Re: North Campus Facilities
Job No: 233901

Subj: Change Proposal No. 233901-0019

We respectfully submit our proposal for an increase to our contract in the amount of \$0 (zero) dollars to provide Alternate #4 - Building f per ASI-14 for the above referenced project.

PROJECT: North Campus Facilities

1 FLOOR PLAN

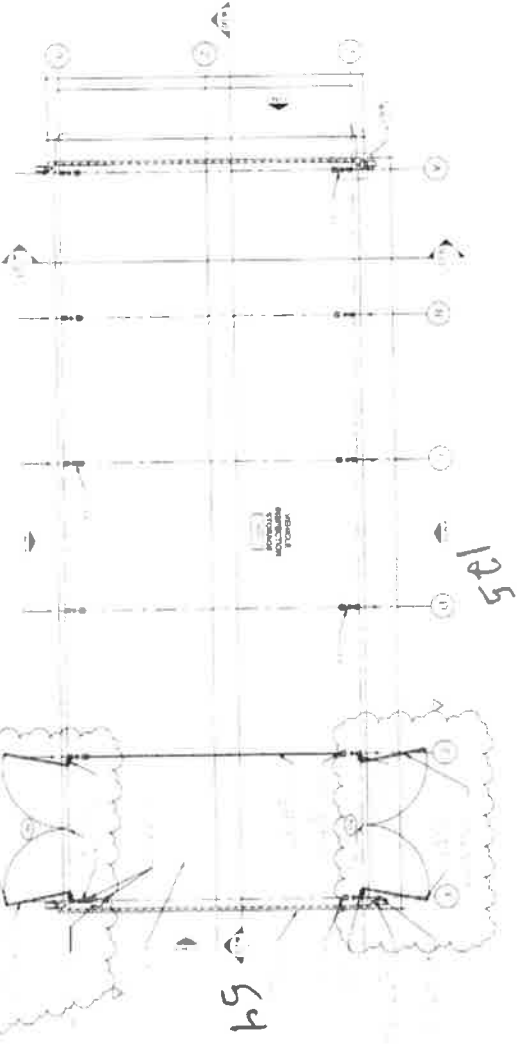
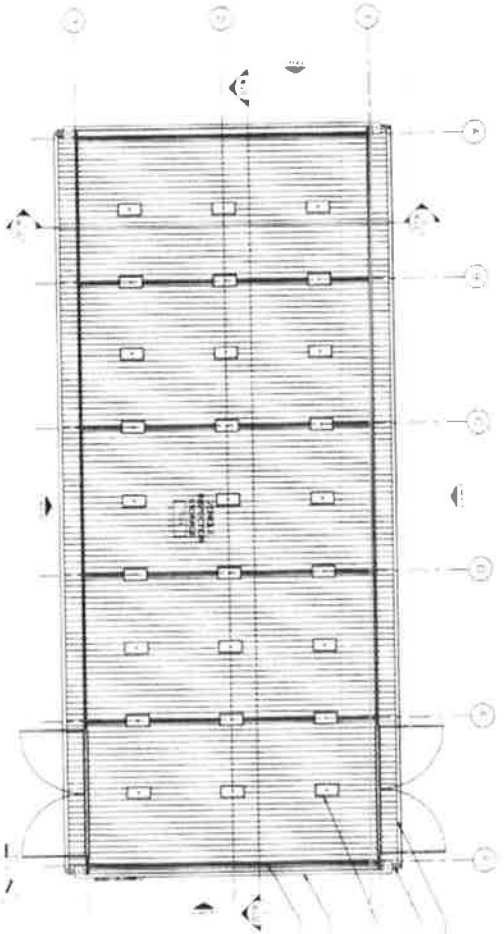
Please (add) the amount below per the items listed in the breakout sheet. This change proposal was based on the plans received on June 14, 2017 for Building "F" per ASI-014.
